SITE AND DRAINAGE PLAN
SCALE: 3/32" = 1'-0"

A NEW CUSTOM RESIDENCE FOR
MR. & MRS. WITHERS
670 Old Compass Rd | Longboat Key, Florida | 34238
Lot 91 | Emerald Harbor | Town of Longboat Key

SITE AND DRAINAGE PLAN

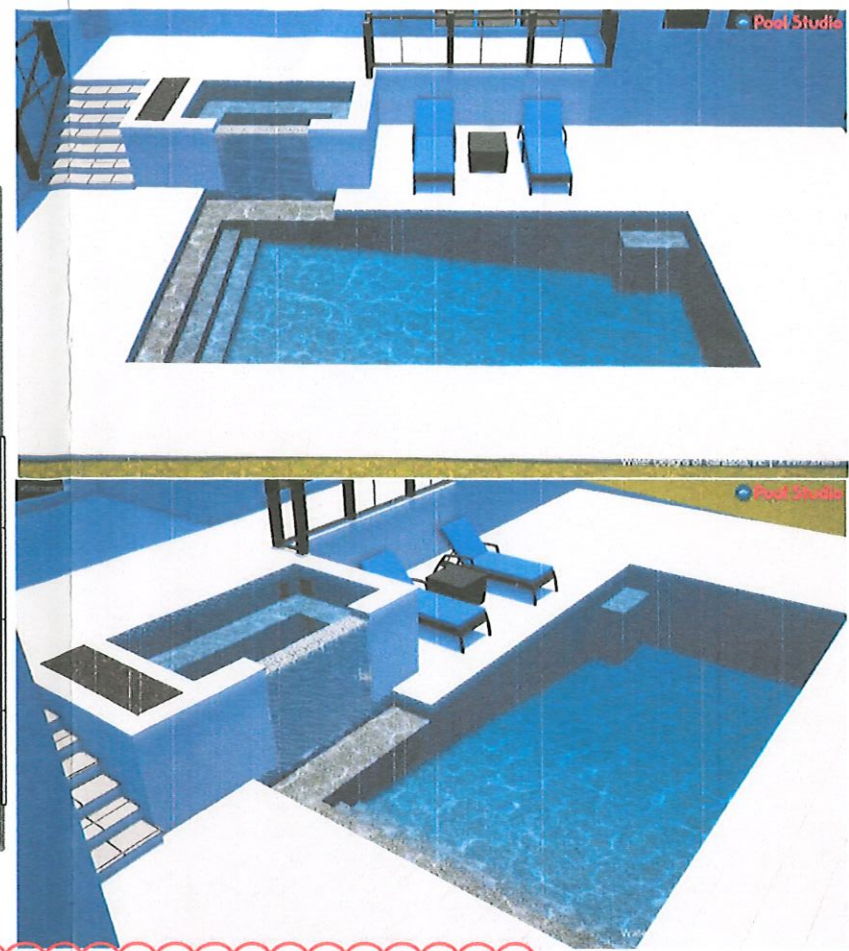
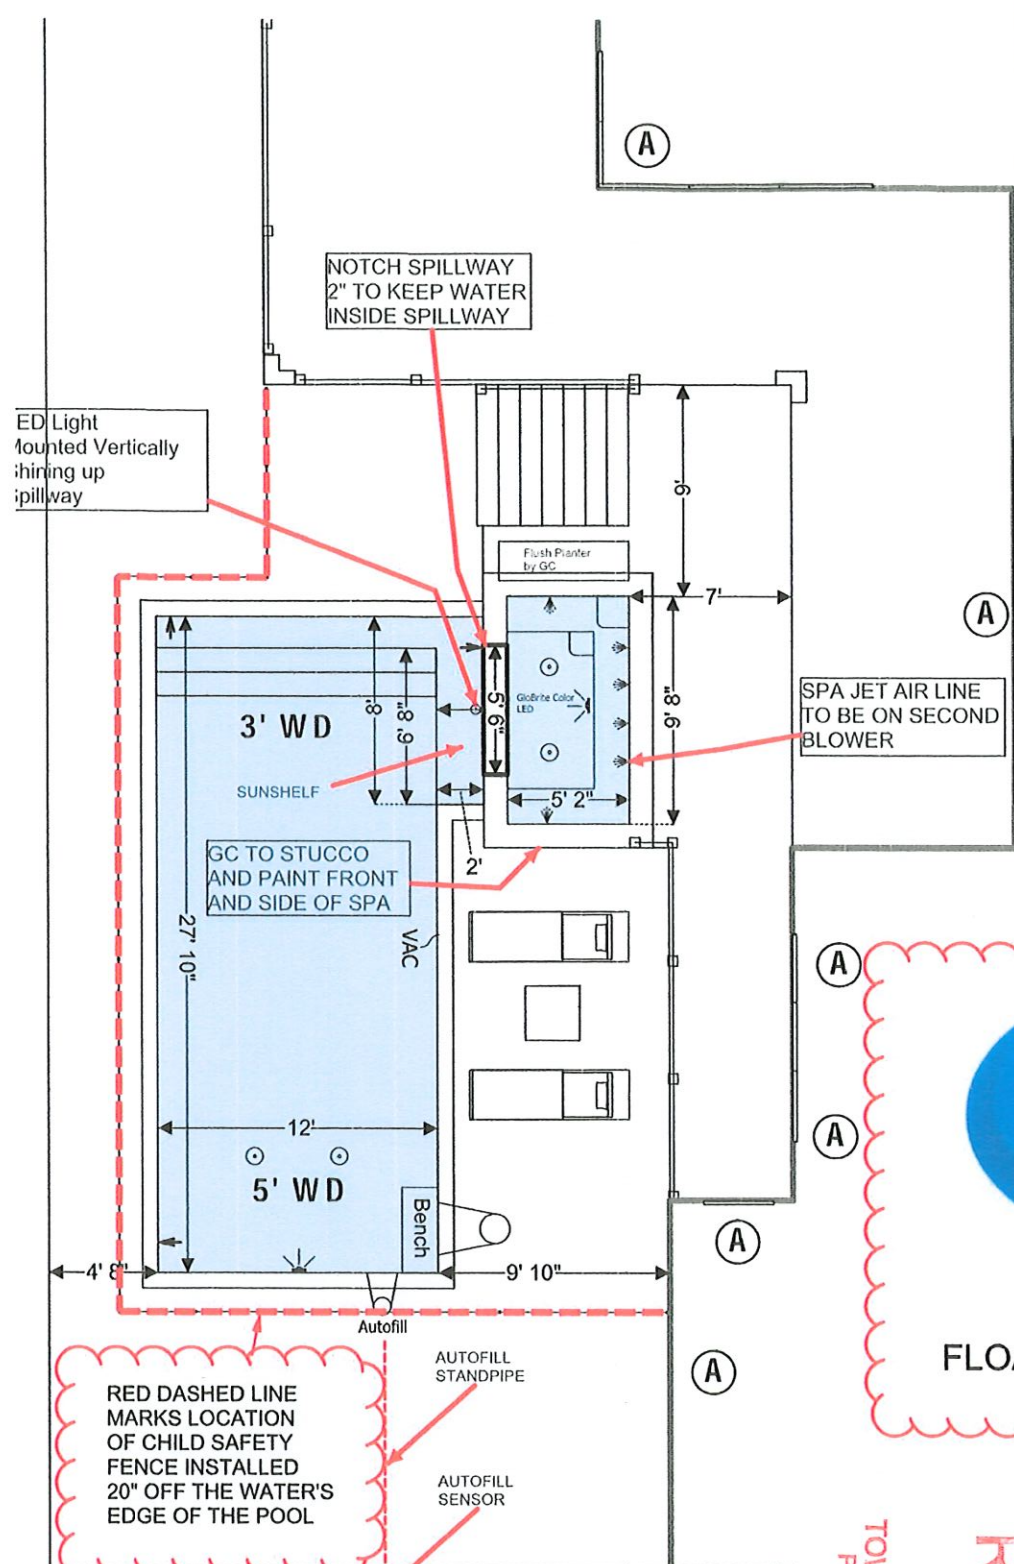
Pool Equipment to have sound mitigating wall min. 2" thick and no less than 18" above equipment
